**City of Pembroke Pines
Planning & Economic Development Department
601 City Center Way 3rd Floor
Pembroke Pines FL, 33025**

Agenda Date:	January 8, 2026	Application ID:	SP2025-0007
Project:	Octane Garage	Project Number:	PRJ2024-0018
Project Planner	Cole Williams, Senior Planner		
Owner:	Dorado Bells LLC	Agent:	Brandon Roth
Location:	18810 Pines Boulevard	Commission District	4
Existing Zoning:	C-1 (Commercial)	Existing Land Use:	Commercial
Reference Applications:	ZC2024-0005		
Applicant Request:	Construction of a self-storage facility with associated site, circulation, parking and landscape improvements.		
Staff Recommendation:	Approval subject to the satisfaction of Fire Prevention's and Engineering's comments at the time of permitting.		
Final:	<input checked="" type="checkbox"/> Planning & Zoning Board	<input type="checkbox"/> City Commission	
Reviewed for the Agenda:	Director:  Assistant Director:

Date: December 9, 2025
To: SP 2025-0007 file
From: Cole Williams, Senior Planner
Re: Octane Garage

Note: Please use Pembroke Pines Fire Apparatus provided below

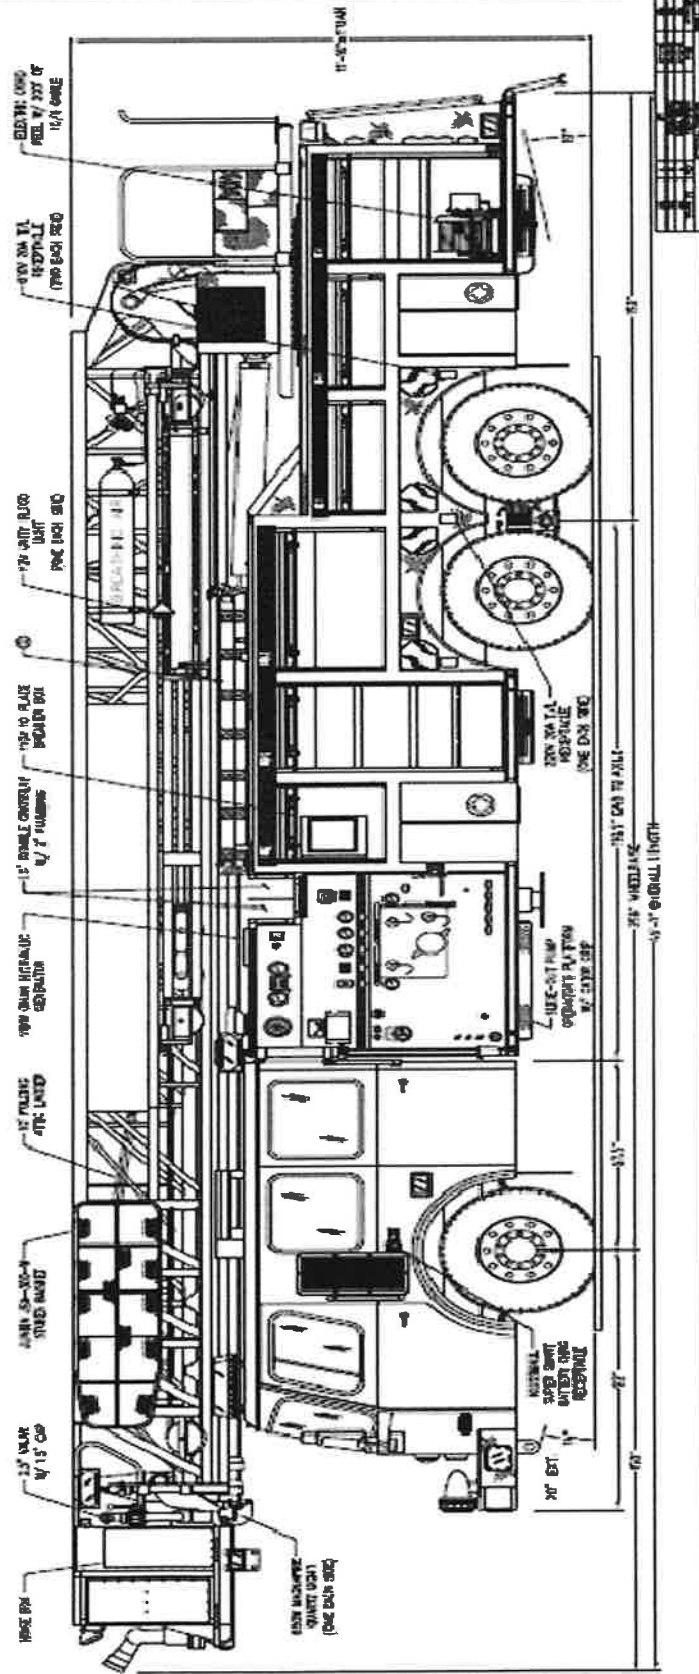
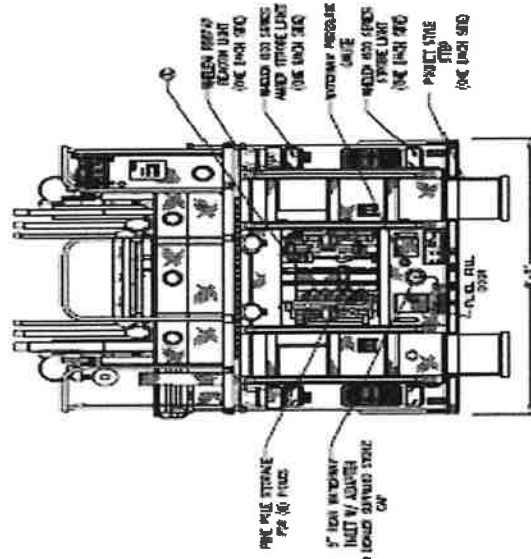
3. Demonstrate on plan: Fire access roads shall be a minimum centerline turning radius of 50'. Show min. 38' inside radius and min 62' outside radius throughout area. Show a shaded truck route including entering and leaving the site with the above turning radius numerals on plans shown throughout.

Note: "All centerline turning radii must be a minimum 50 feet." **COPP CO 154.35 (3)**

Note: A separate sheet must be provided when the plans are submitted demonstrating the fire apparatus ability to maneuver throughout the fire access road using the fire apparatus specifications provided.

FIRE HYDRANT DETAIL

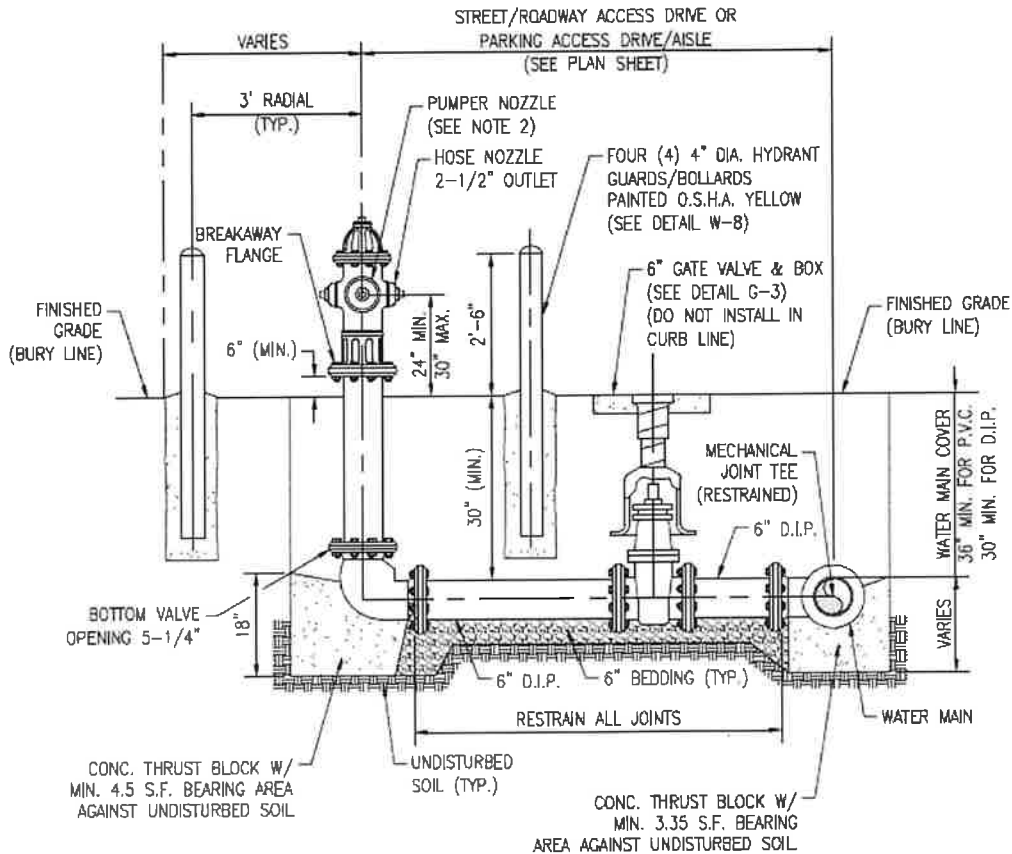
NOTE: Fire Hydrant Detail to be provided on submittal.

i. No tree, bush, hedge, or shrub, shall be planted within 15 feet diameter of a hydrant and located such that the hydrant shall be fully visible from the street. **COPP CO 93.25 (F)**
